September 13, 1984

HOPE CREEK GENERATING STATION
DOCKET NO. 50-354
DRAFT SAFETY EVALUATION REPORT
OPEN ITEM STATUS

Enclosed for your review and approval (see Attachment 4) are the resolutions to the Draft SER open items, and NRC questions listed in Attachment 3.

SERVICE WATER INTAKE STRUCTURE - FLOOD PROTECTION

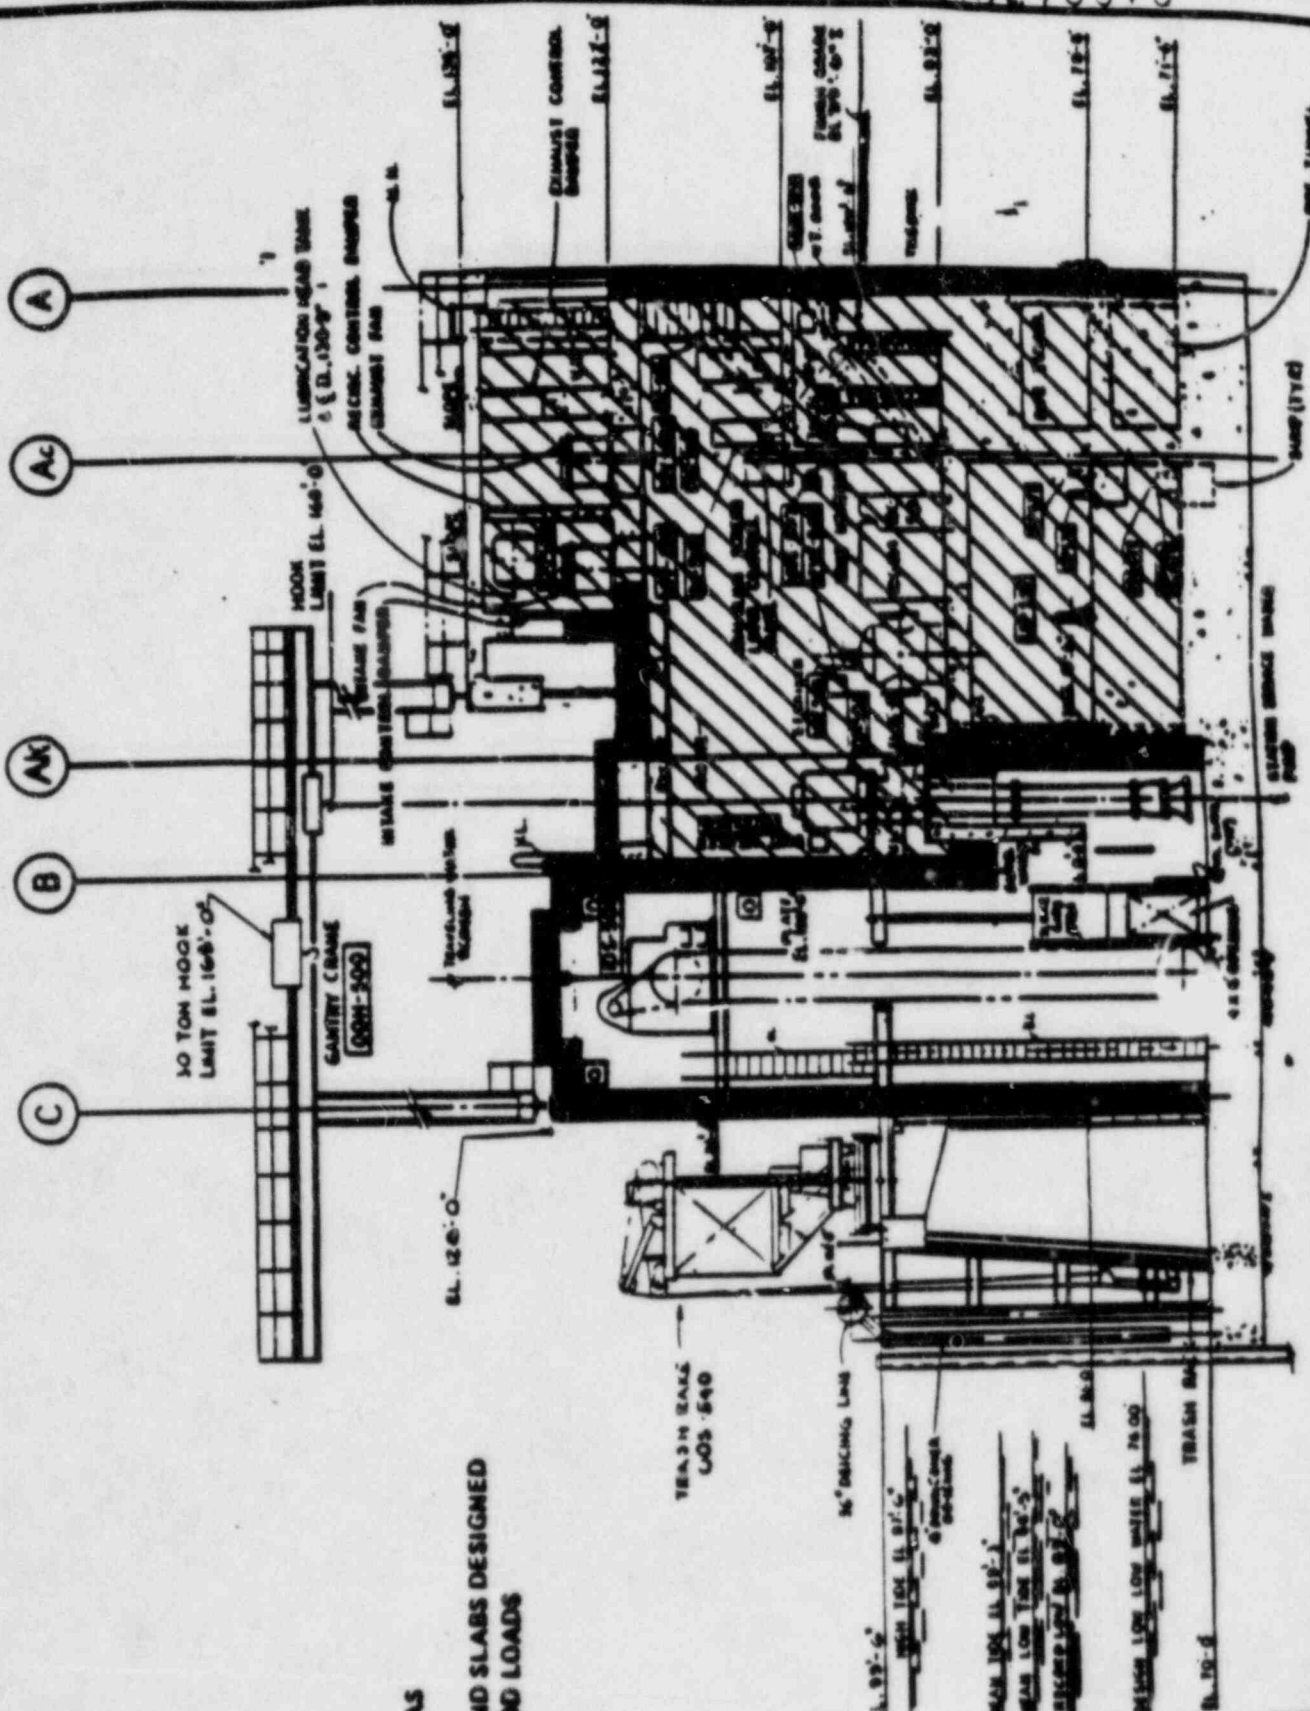
Provide a figure(s) in the FSAR which shows the protection of the station service water system from the flood water (including wave effects) of the design basis flood.

The general arrangement of the intake structure is provided in Figures 1.2-40 and 1.2-41. Section AA of Figure 1.2-41 is reproduced here as Figure 410.69-1 which identifies the water-tight areas and the walls and slabs designed to accommodate flood loads. As described in Sections 2.4.2 and 2.4.5, the south and west exterior walls of the intake structure are subject to a maximum wave run-up elevation of 134.4 feet due to the probable maximum hurricane (PMH). Such waves could overtop the roof of the western portion of the structure at elevation 128 feet. However, a rigorous analysis has been performed to determine the depth of water in the low area (elevation 122.0 feet) after wave impact and to confirm that water does not enter the building through the air intake control dampers (bottom elevation 128.5 feet). Therefore, flood water will not enter into the dry area of the intake structure. On the north side of the intake structure, the maximum water level will be only slightly higher than the still water elevation (113.8 feet) during the PMH. According to Table 2.4.6, the maximum wave elevation for the north side of the intake structure is 26.3 feet MSL (elevation 115.3 feet) due to a postulated multiple dam break. Therefore, flood protection of the north exterior wall to elevation 121.0 feet is adequate.

On the east side of the intake structure, the maximum wave run-up elevation due to the PMH equals 122.3 feet. This elevation is due to a 1% wave traveling in the direction of Fetch "A". Fetch A, which is rotated about 15 degrees from Fetch 1 (as shown in Figures 410.69-2 and 410.69-3), is chosen to maximize the wave run-up elevation. Elevation 122.3 feet exceeds the elevation of the bottom of the HVAC exhaust openings at elevation 122.0 feet by 0.3 feet. Curbs will be added at the bottom of these openings to prevent water from entering into the building.

Fig. 1 Fetches for Service Water Intake Structure, Hops Creek Generating Station

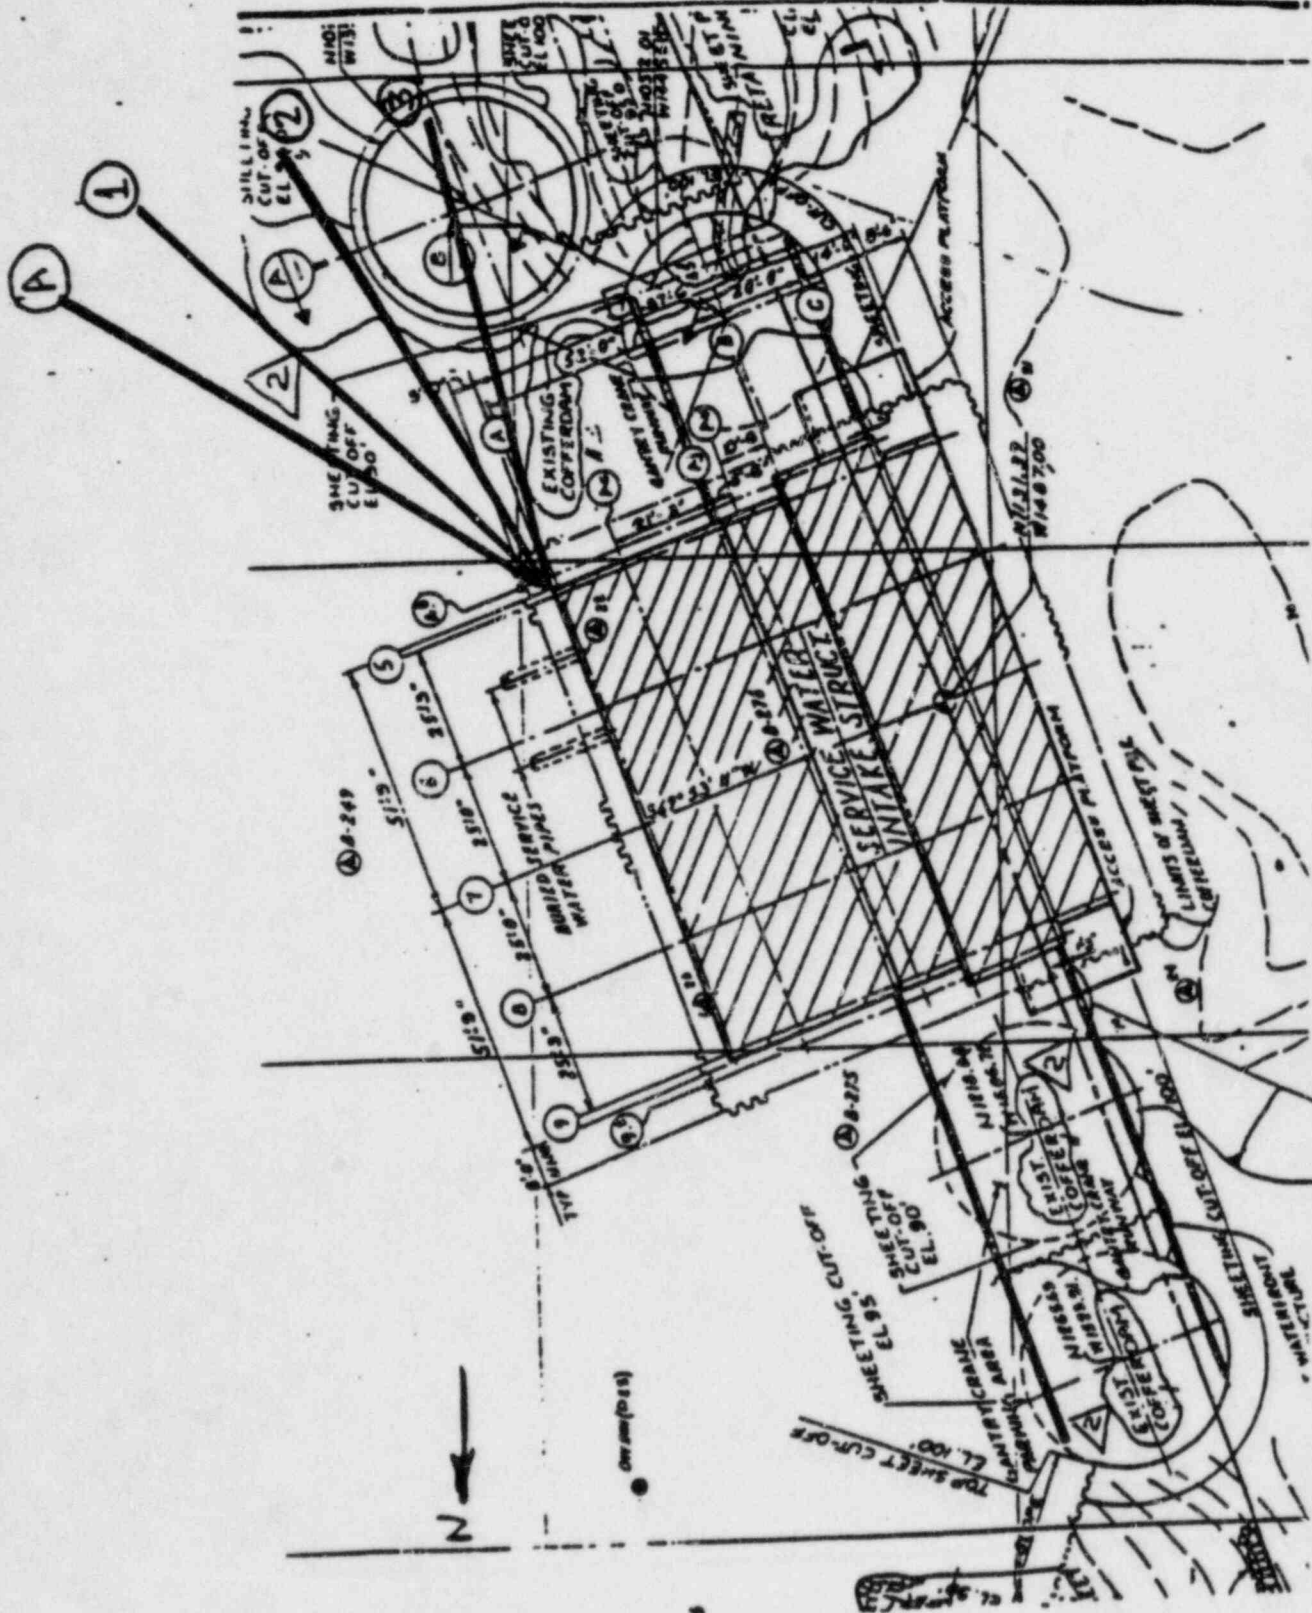
The staff has requested the applicant to provide additional information on the waves that impact on the river face of service water intake structure. The waves impacting on this face of the structure are not reduced in height (depth-limited) as those that traverse plant grade.

The attached Figure 1 shows the fetches considered for wave runup on the service water intake structure. Fetch A which has a direction of N58°W, is 4800 feet long and passes between the Salem Plant and the Hope Creek Generating Plant.

Energy will be added by wind shear along Fetch A. The energy addition was computed in accordance with Figures 3-24 and 3-25 of Reference 2 which give a dH/dx equal to 0.00014. For an additional fetch of 4800 ft. a total gain in wave height would be 0.65 ft. ($0.00014 * 4800$) due to wind shear.

Energy dissipation was estimated on the basis of Figure 3-34 of Reference 2. A friction coefficient of 0.04 was assumed for the conditions along Fetch A which will exist once the plant goes into operation. This assumption gives a K_f value of 0.54. Thus the propagated significant wave height would be:

FIGURE B-3-11 SHEET 2 OF 5

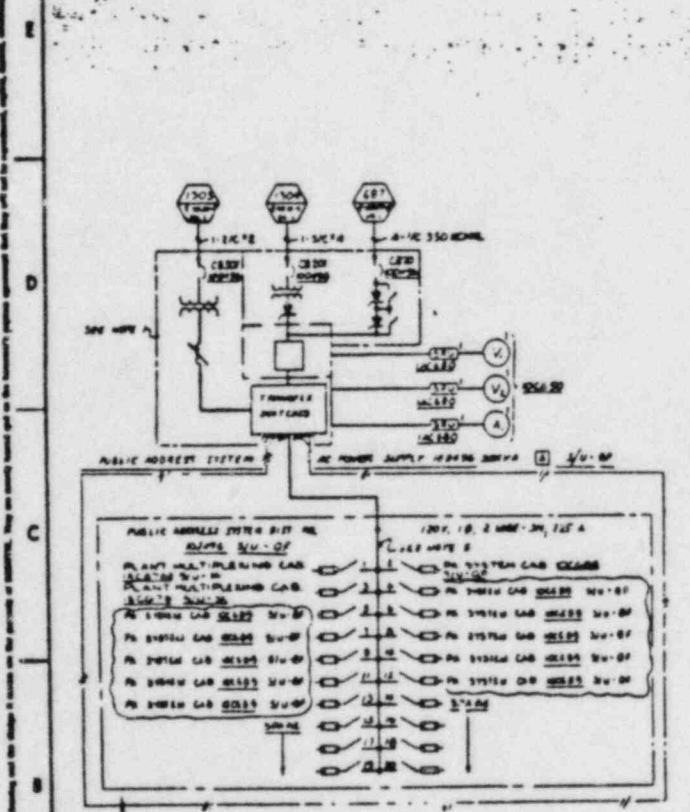
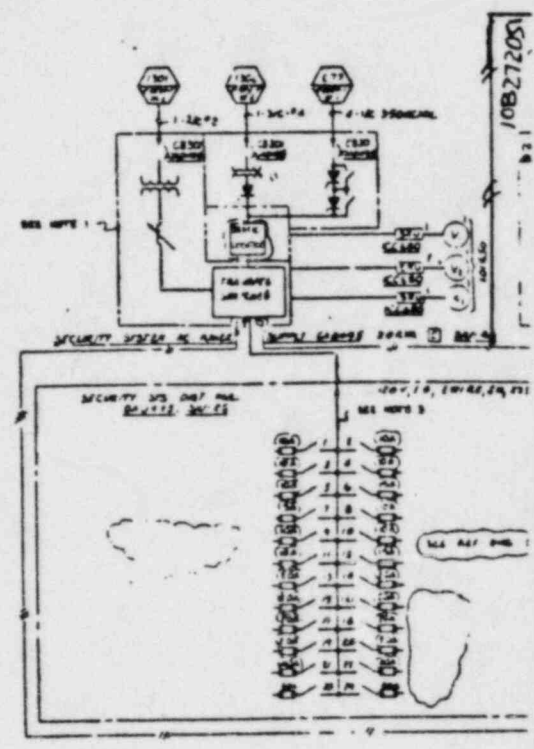
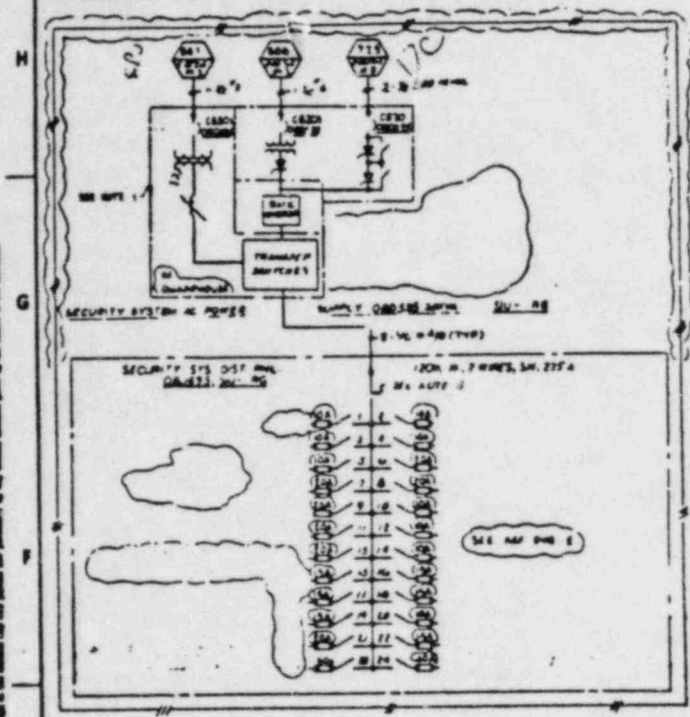
In Sections 8.1.4.1, 8.3.1.1.2.4 and 8.3.2.2 of the FSAR you state that no provision exists for either automatic or manual transfer of loads between redundant load groups. The design depicted by this statement meets the requirements of Criterion of Appendix A to 10 CFR 50, the guidelines of Regulatory Guide 1.6 and is, therefore, acceptable. However, based on staff review of single line diagrams presented in Section 8.3 of the FSAR, provision for both automatic and manual transfer of loads have been identified. Sheet 2 of Figure 8.3-11 (E-0012-1) of the FSAR shows the non Class 1E BOP computer load normally connected to Class 1E division "D" with provision for automatic transfer to divisions "B" or "C". In addition, Sheet 5 of Figure 8.3-8 (E-0009-1) of the FSAR shows the non Class 1E loads on 125 v DC bus 10D486 having provision for manual transfer between Class 1E divisions "A" and "B" and the capability for simultaneous connection of this same load to both division "A" and "B". Similar provisions for load transfer also exists between division "C" and "D".

FSAR FIG 8.3-11 SHEET 2 HAS BEEN REVISED
TO SHOW THAT THE BOP COMPUTER

POWER SUPPLIES IAD492 AND IBD492,
ARE POWERED FROM NON-CLASS I E
ELECTRIC POWER SOURCES. THERE ARE
NO MANUAL OR AUTOMATIC PROVISIONS
FOR TRANSFERRING LOADS BETWEEN
REDUNDANT AC OR DC ELECTRIC
POWER SUPPLY CHANNELS.

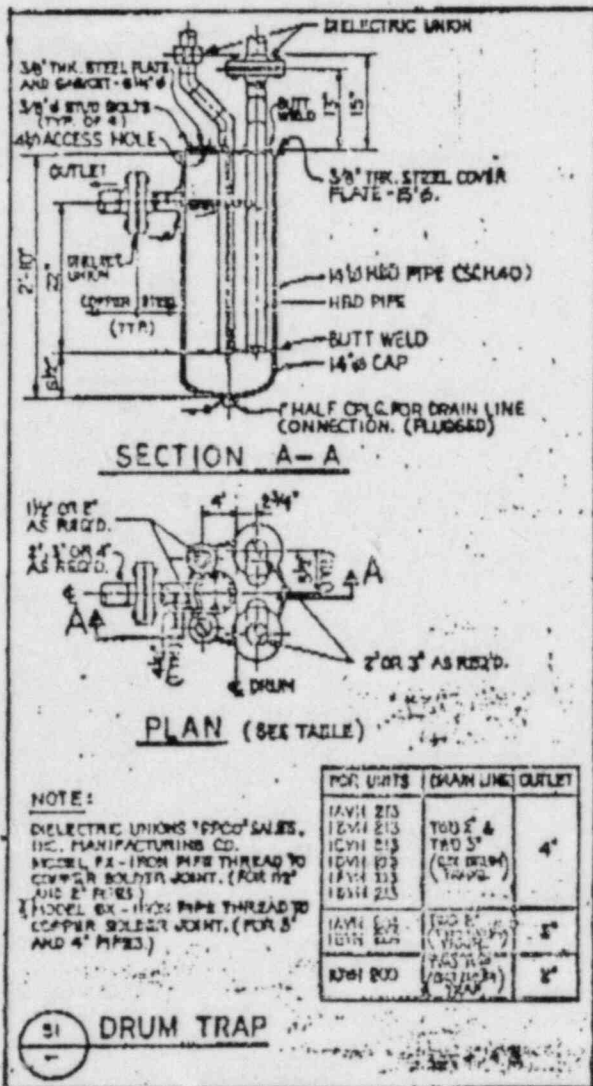
Water filled drum traps are provided on the drain line from the ESF FRVS recirculation units and the FRVS vent units. They are also provided on the non-ESF CPCS system. Refer to FSAR figures 9.4-4 and 9.4-5. These drum traps are periodically filled with water to its outlet in order to maintain a 20" unit drain line submergence. Refer to the attached drum trap detail.

The rate for the CPCS unit drum trap is 0.0076 lb/hr or a drop of 1 inch in 26.6 days.

The maximum static pressure that any drum trap would see during normal system operation is 15 inch WG. Thus 5 inches could evaporate before a loss of water seal would occur. This would take longer than 26.75 days (5.35 days/in. x 5 in.) Since the 104°F conditions described above would not last this long. At 80°F air and water temp. and 20% RH the evaporation rate is only 0.00424 lb/hr. or 11% of the maximum rate for the FRVS recirc. units.

With the removal of the access hole cover, which will be implemented in the design, the evaporation rates will be as shown on the attached table.

The bottom elevation is 101 ft. (PSE&G Datum) which makes the depth equal to 11.1 ft. ($112.1 - 101.0$). Thus, the initial significant wave height to be propagated along Fetch A is $0.4 * 11.1 = 4.4$ ft.

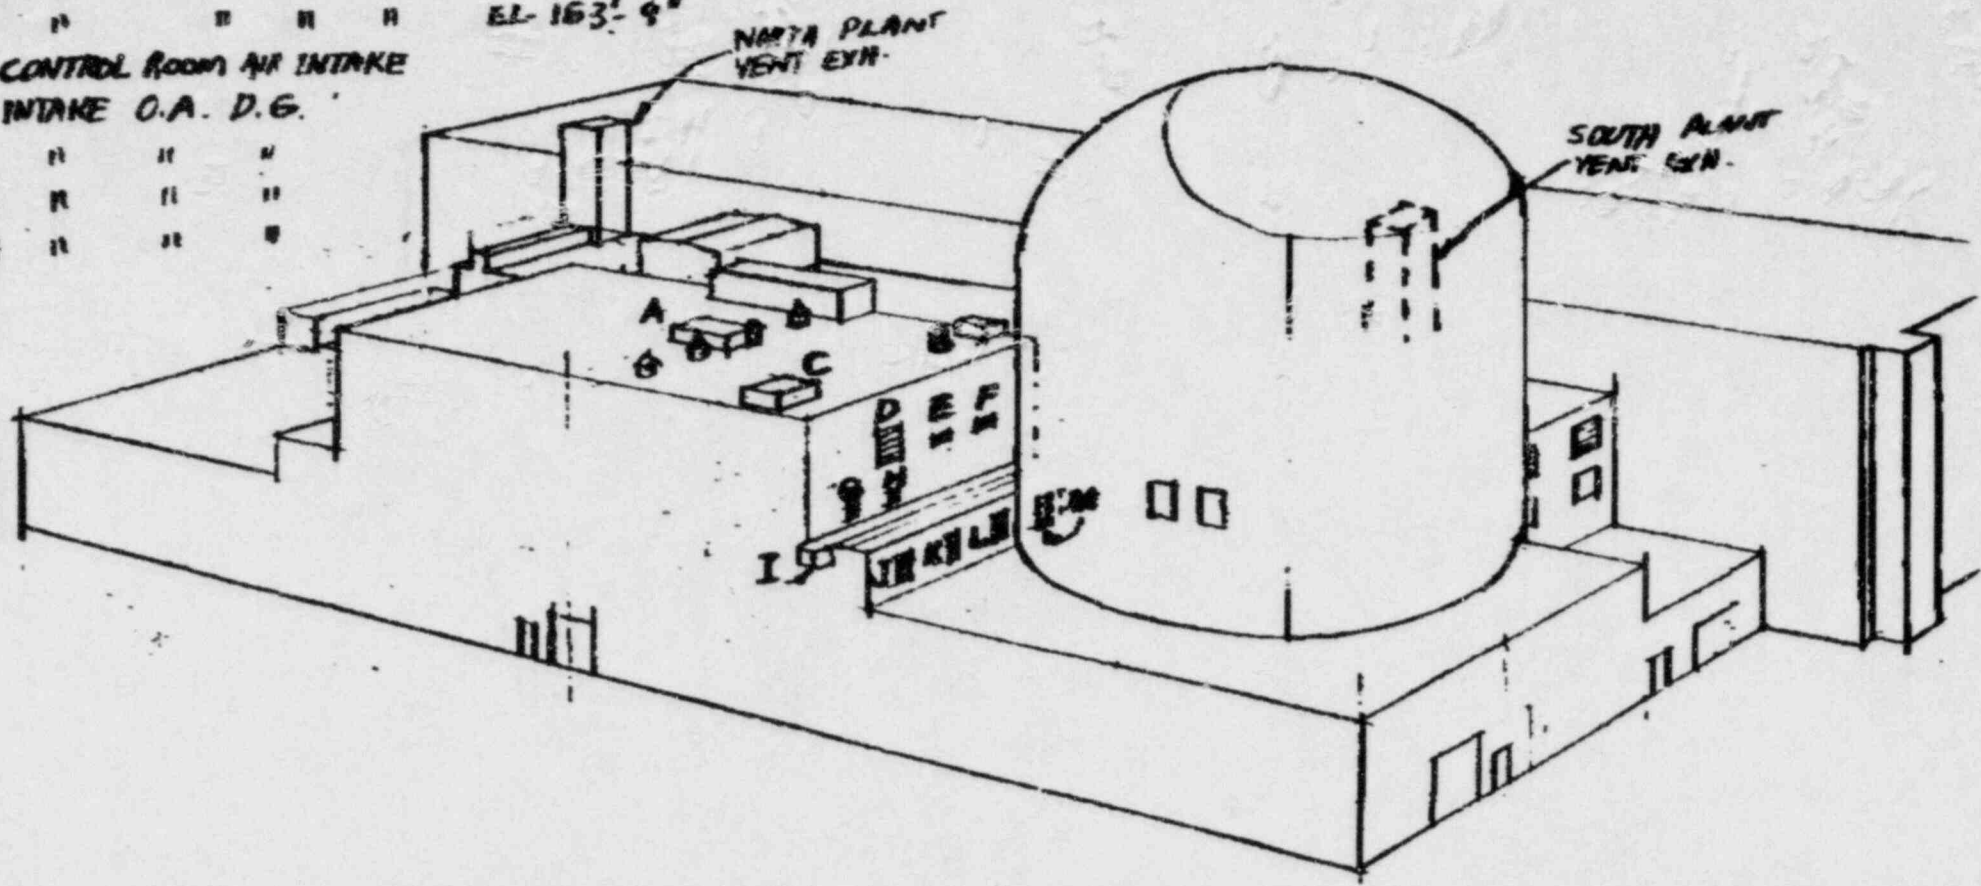
References

1. Weggel, J. R., "Wave Overtopping Equation" Proceedings of the 1976 Coastal Engineering Conference.
2. Jackowski, R. A. (Editor) Shore Protection Manual, U. S. Army Corps of Engineers, Coastal Engineering Research Center, 1977.
